Department of Water Resources

COMMUNICATION DOCUMENTATION

SUBJECT: 43-07322

photo looking NE'ly from farm rd

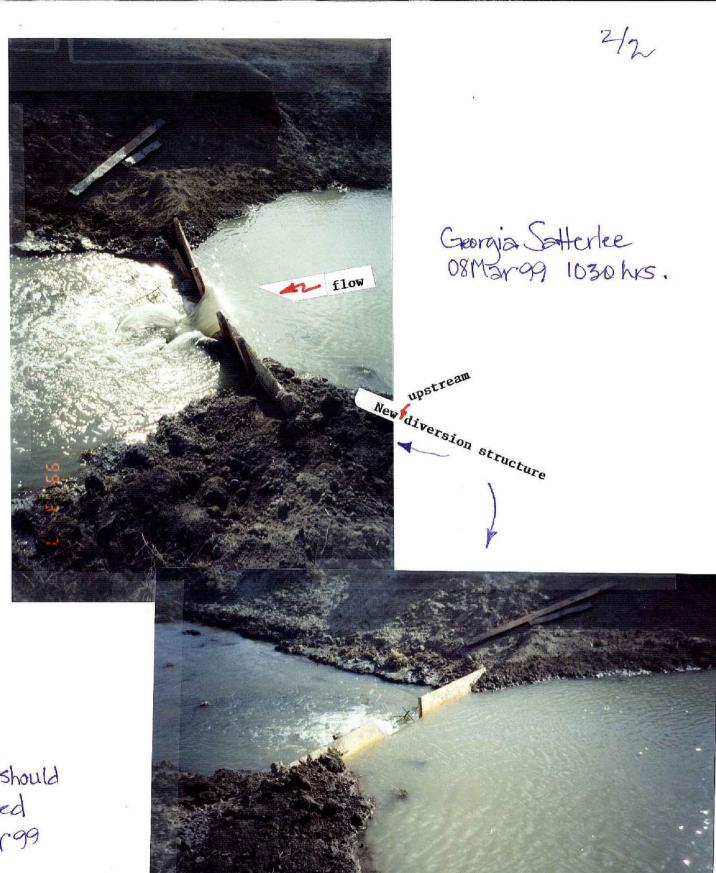
I met with Dave Sundberg and Garth Steed. The new structure still isn't up to par. See photographs. The items that will corrected:

1. The rectangular weir will have a crest length of 2.0'.

2. The fall distance seems to be acceptable, however the structure was leaning downstream and it will be necessary to plumb it up.
